January 16, 201650613-02943 Version 3

2011–14 Odyssey: MIL Comes On with DTC P0404

(Supersedes 13-095, dated November 18, 2013, to revise the information highlighted in yellow)

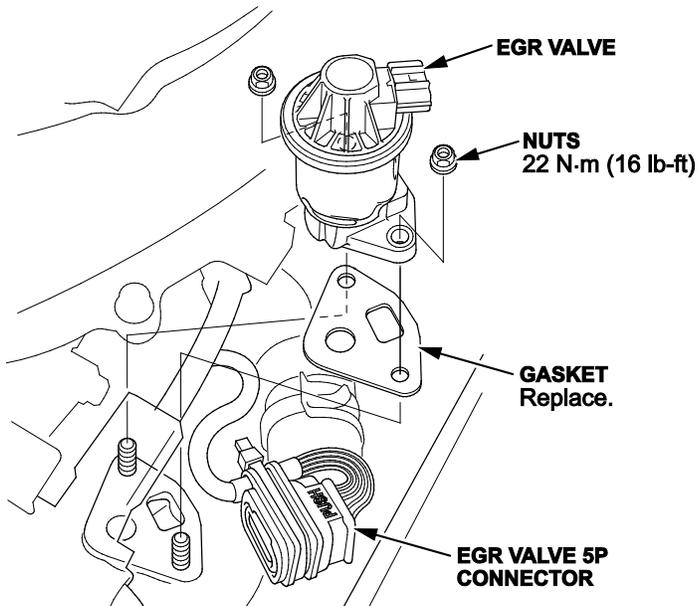
1. Remove the engine cover.

2. Disconnect the EGR valve 5-pin connector

3. Remove the EGR valve.
 4. Install the new EGR valve in the reverse order of removal and torque the nuts to **22 N-m (16 lb-ft)**.
 5. Update the PGM-FI software. Refer to Service Bulletin 01-023, *Updating Control Units/Modules*.
- END
